Grimes Planning and Zoning Commission

Planning and Zoning Commission October 3, 2023 @ 5:30 p.m. **In Person at Grimes Community Complex, 410 SE Main Street, Room 202**

1. Willow Hills North Plat 1 Final Plat
2. Hope Meadows Plat 1 Final Plat
3. 212 SE Main Street Rezone
4. 212 SE Main Street Site Plan

RE: Willow Hills Plat 1 Final Plat

WILLOW HILLS NORTH PLAT 1 GRIMES, IOWA FINAL PLAT

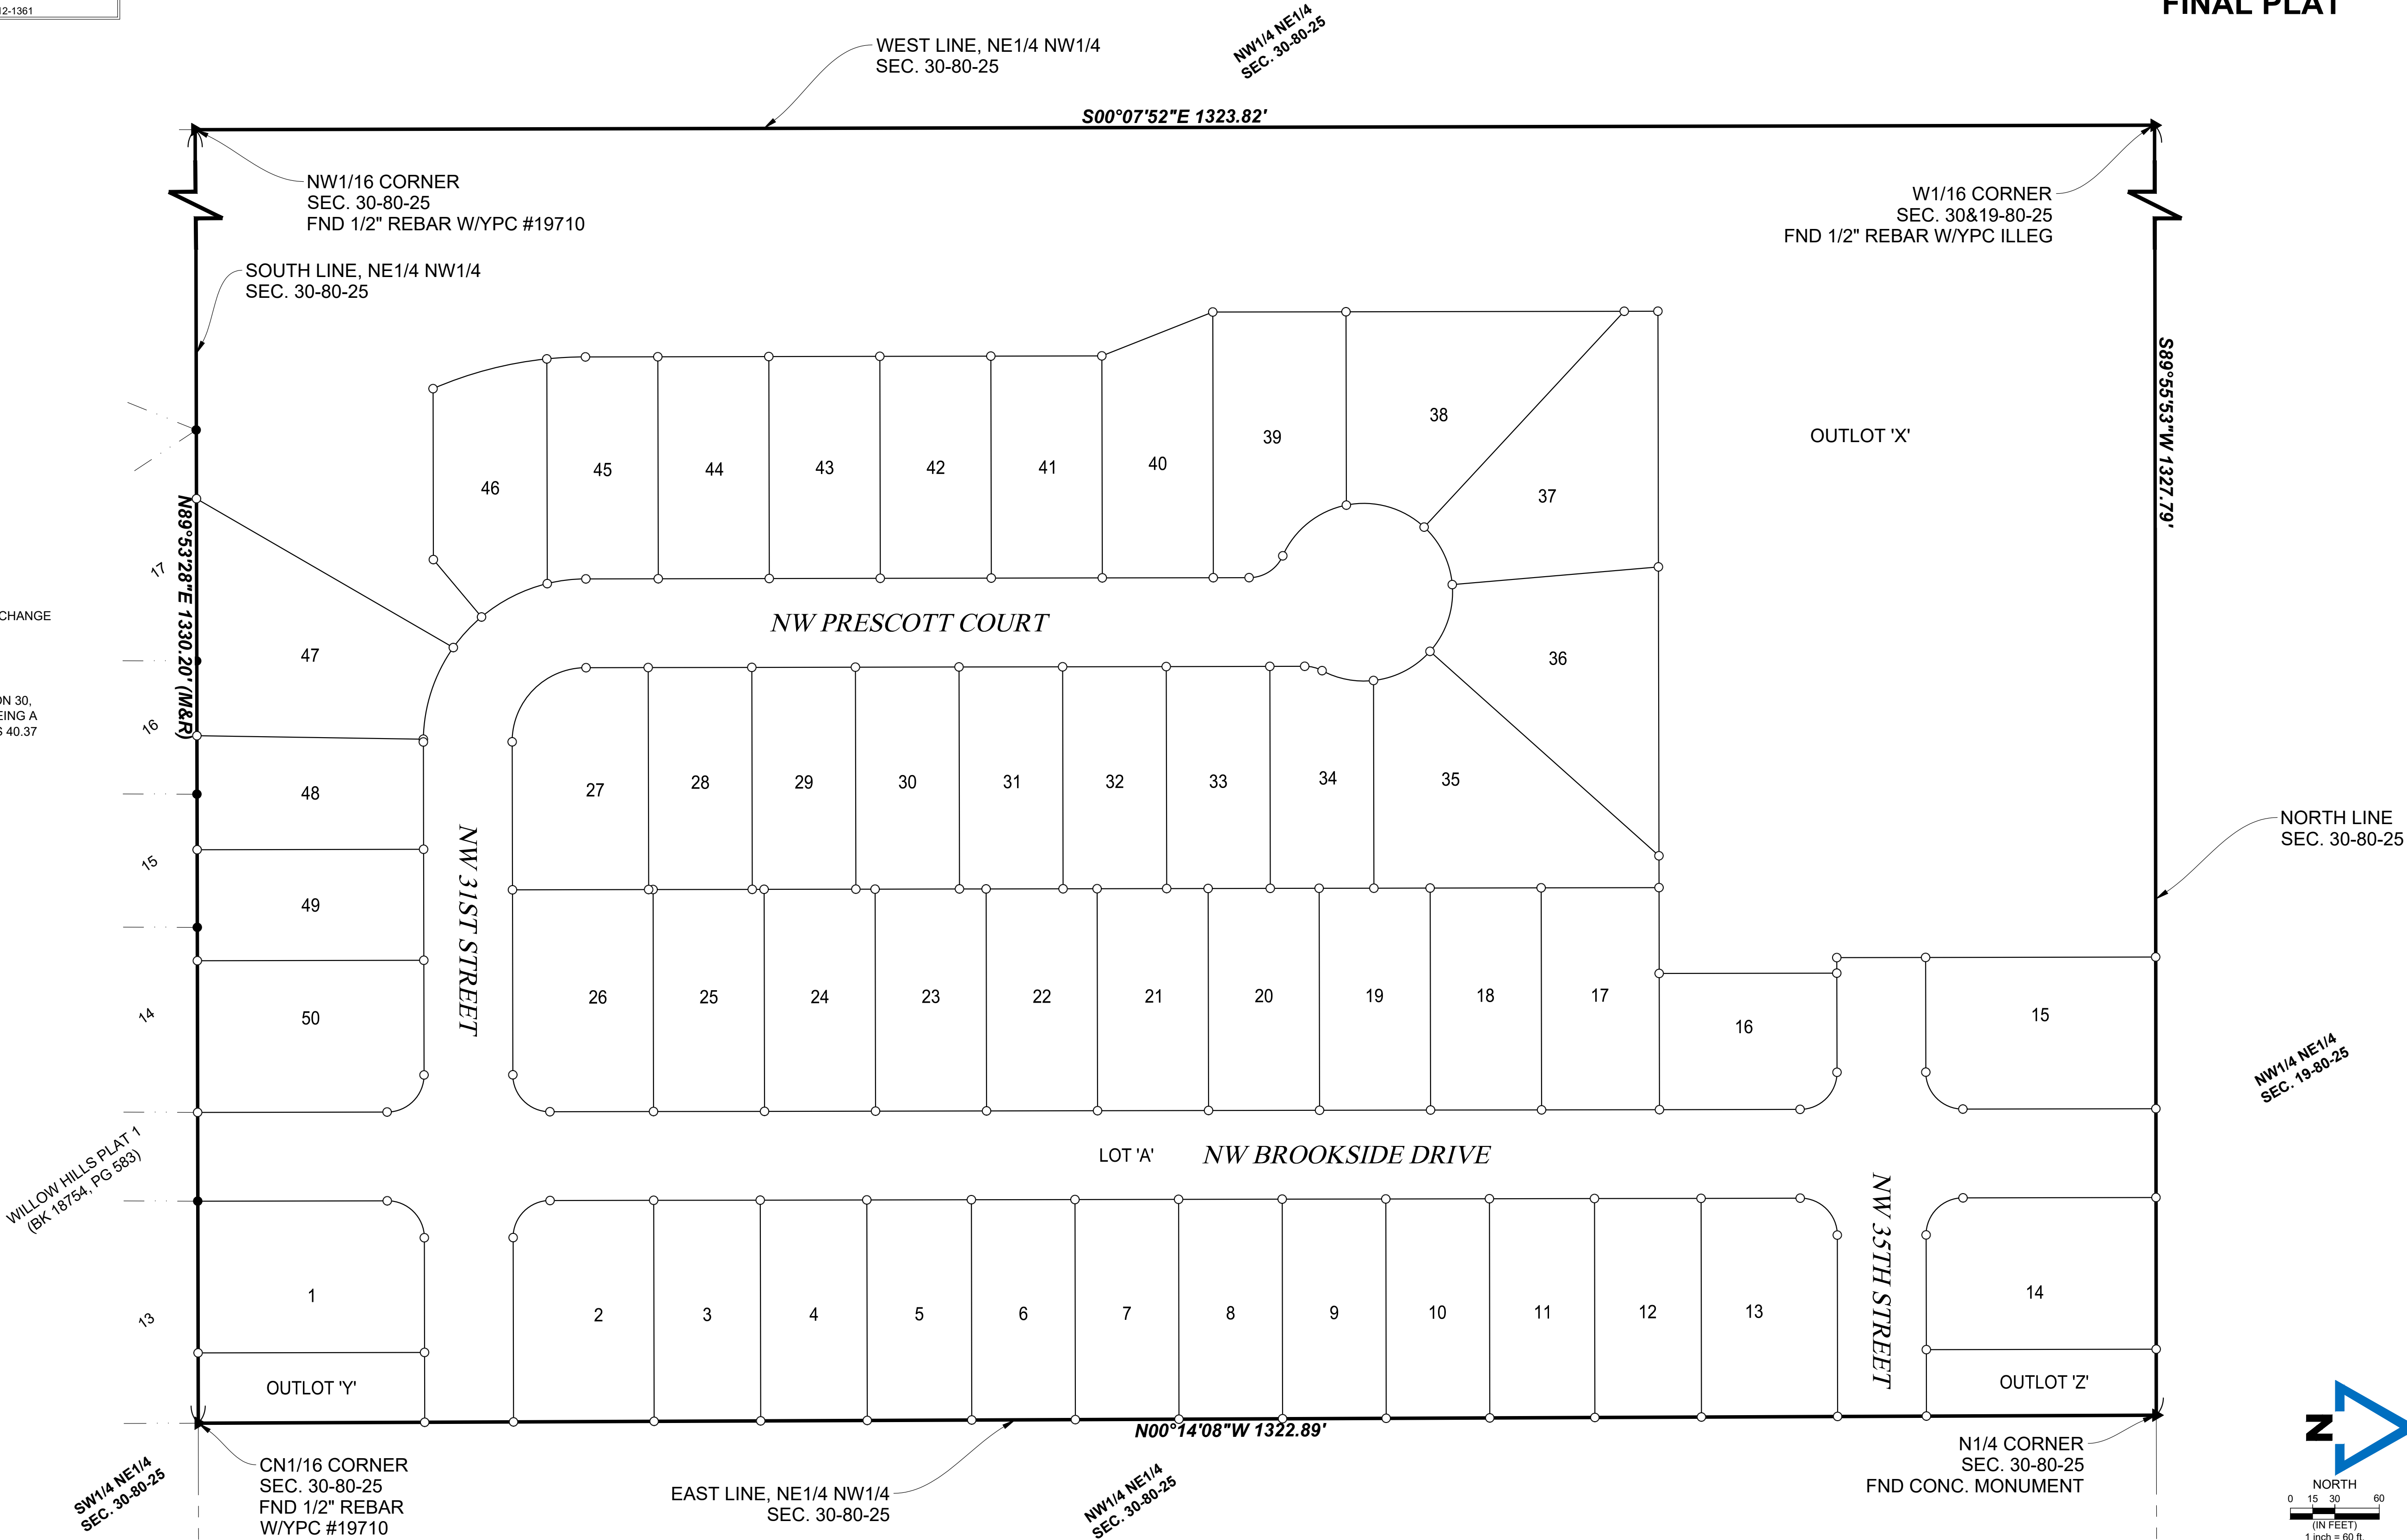
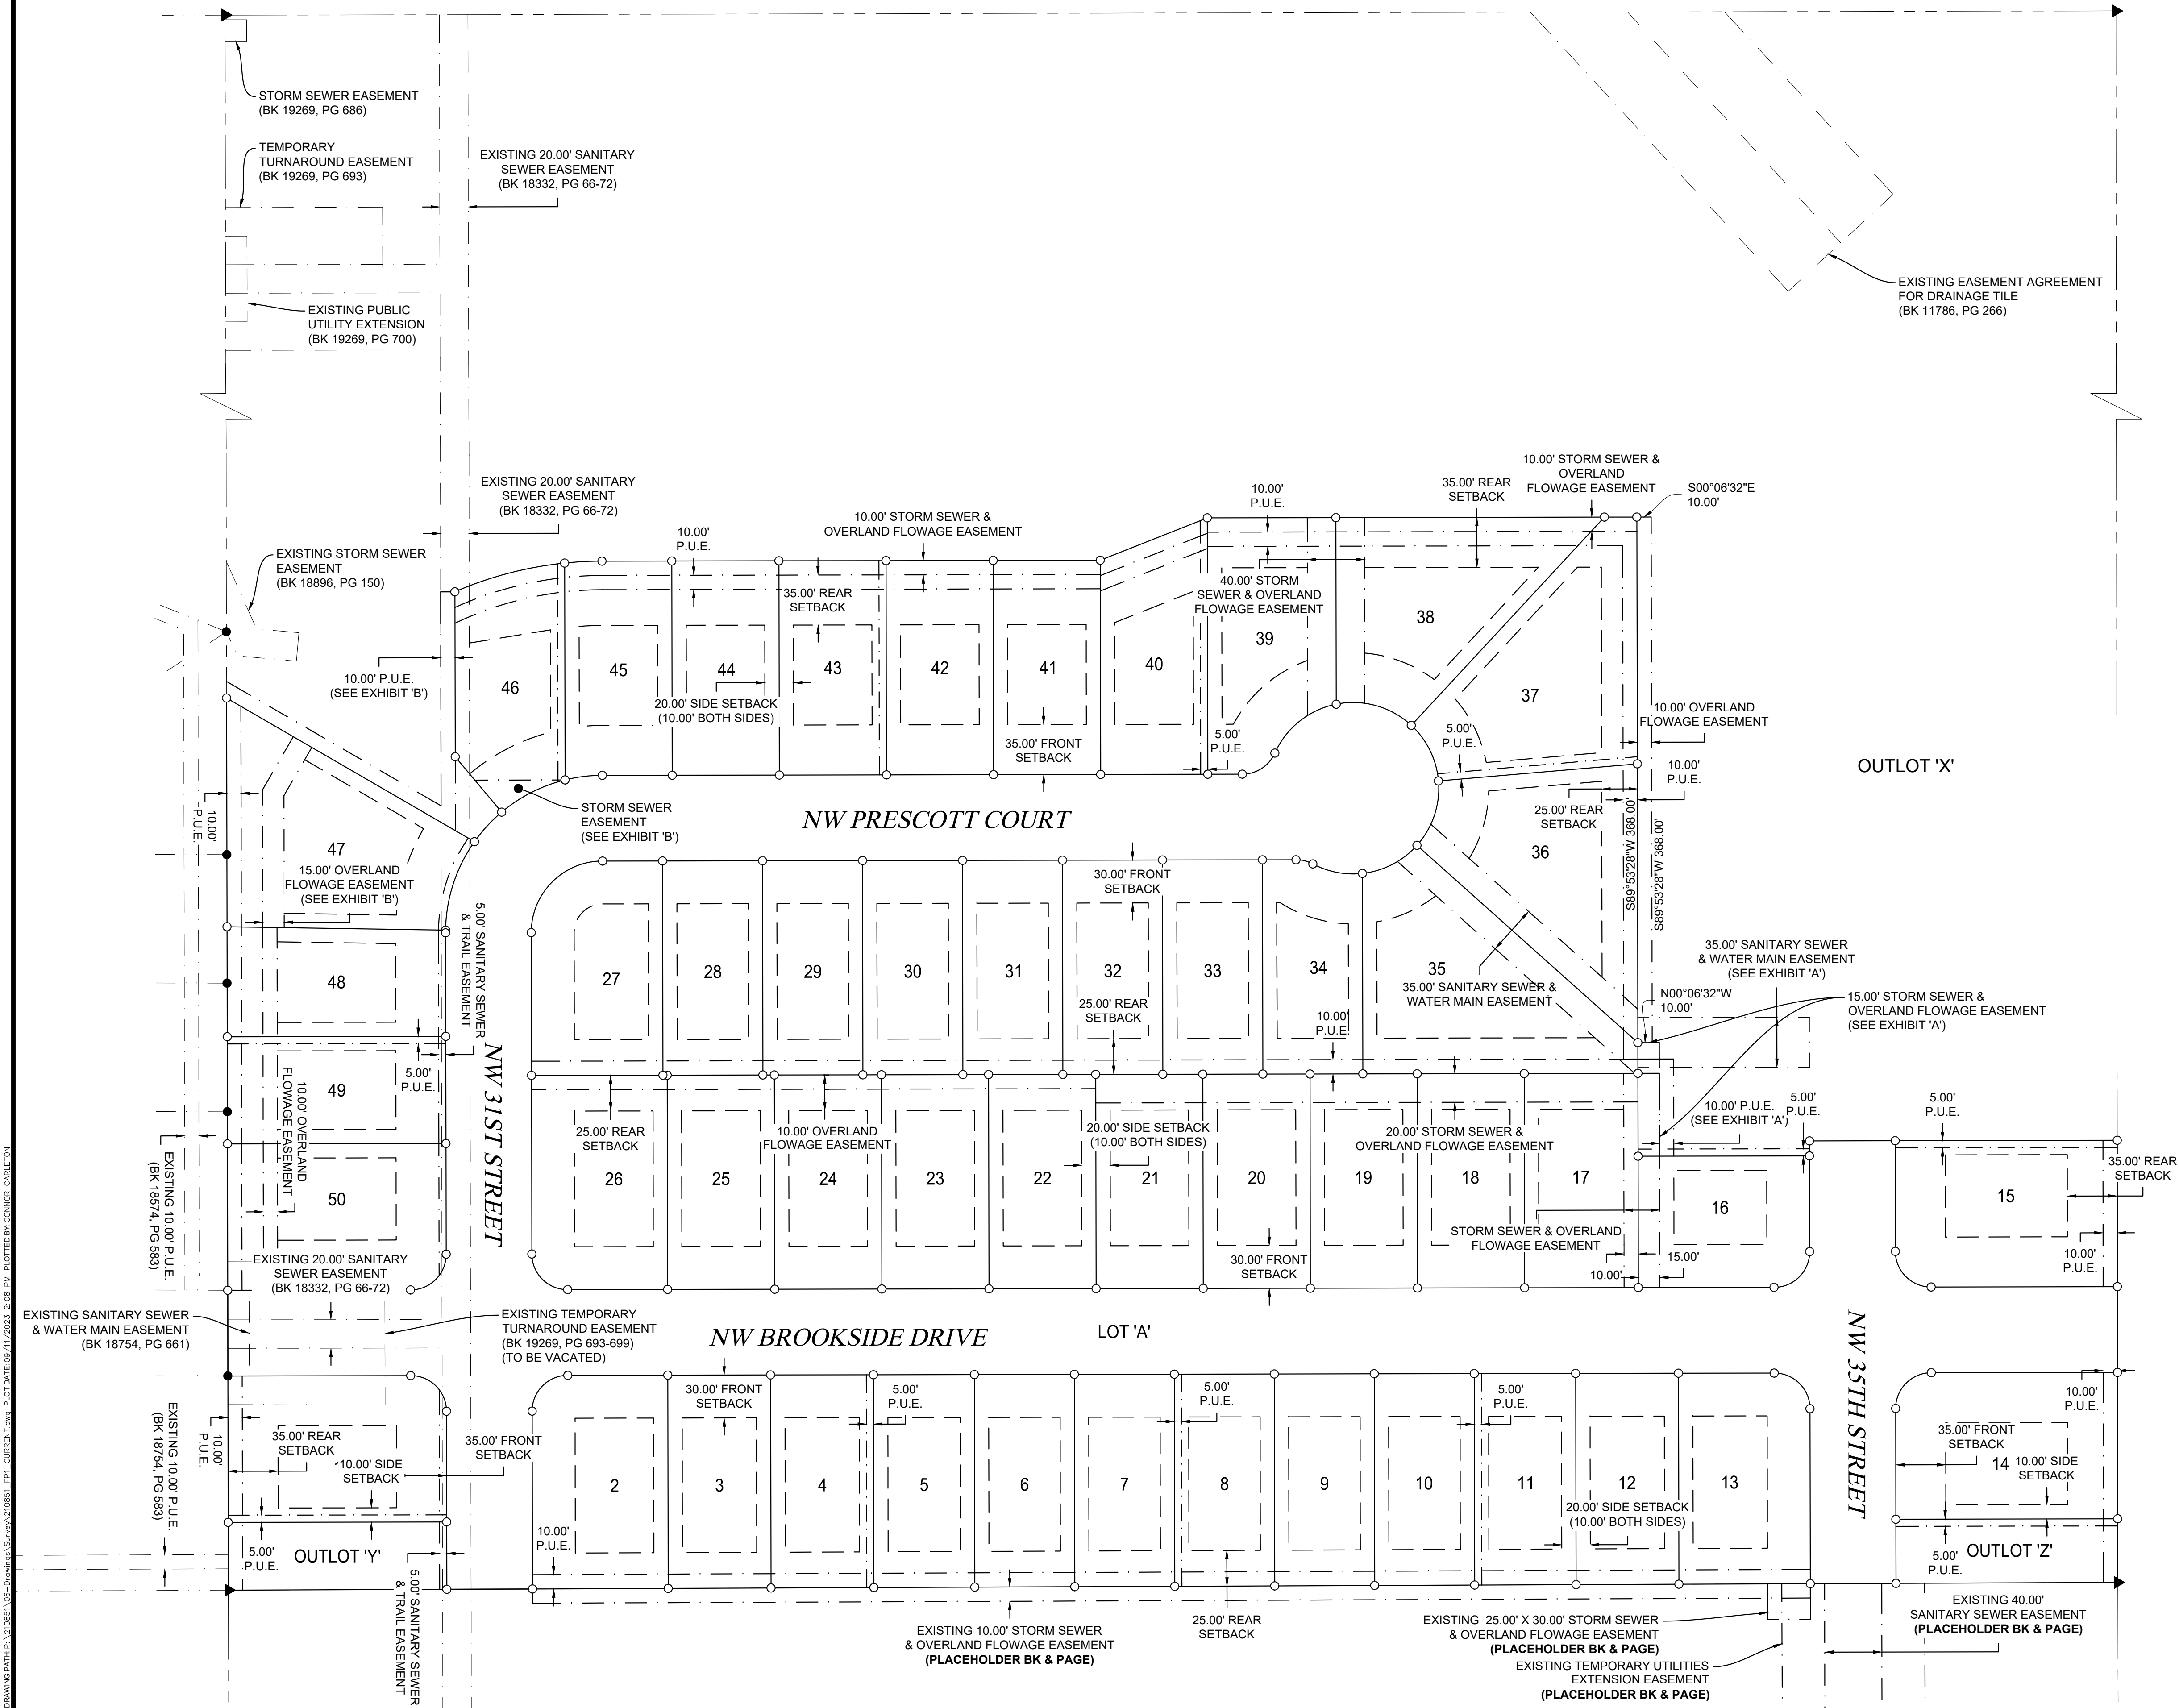
1. Provide an MPE sheet signed by the engineer listing the MPE for each lot. **Please provide a table with lot numbers and MPEs with an engineer stamp.**

2. ~~Label the area in Phase 2 as an outlet.~~
3. ~~Revise the legal description to cover the entire 40 acres.~~
4. ~~Add a note that street lot A will be dedicated to the City of Grimes.~~

5. ~~Add a reference to the zoning change and development agreement BK 19021 PG 797-807.~~
6. ~~Lot 41-46 are less than the minimum 11,000 sf for the R-1 zone and need to be enlarged. It looks like an extension of 6-7' to the west would fix it. It looks like some of the lots in Phase 2 will need to be adjusted as well.~~

7. ~~Remove "to be recorded in separate document" from the easements on the Marco Properties property. These documents should be recorded prior to the plat recording and referenced with a BK PG on the plat. Once final easement documents are received, staff can prepare them for Council approval and recording and provide the BK PG.~~

8. Remove "off site" and "to be recorded in separate document" from the easements on the outlot for the phase 2.
9. Is there a difference between the overland flowage easement and the drainage easement? Can these both be named overland flowage?
10. Label the storm sewer easement for the subdrain behind Lots 5-13.
11. Change NW Crescent Ct to NW Prescott Ct.
12. Please update Lot 25 address to 3150. This will prevent potential addressing confusion between Lots 24/25.
13. Label storm sewer easement on the west side of Lot 17 as shown in the construction drawings.
14. Please move the label for the 15' storm sewer and overland flowage easement so it isn't covering the easements.

16. ~~Remove the offsite water main easement on the property owned by Marco Properties.~~
17. ~~Change the off-site temporary turnaround easement to “off-site temporary turnaround and utilities easement”. Change to “temporary utilities extension easement” since a turnaround will not be constructed.~~
18. Provide a 10' storm sewer easement from the storm pipes in the front and rear of Lot 46. The southwest corner should still have an easement 10' from the pipe to provide room for maintenance.

Provide updated legal descriptions for the overland flowage easement and the storm sewer and overland flowage easement.
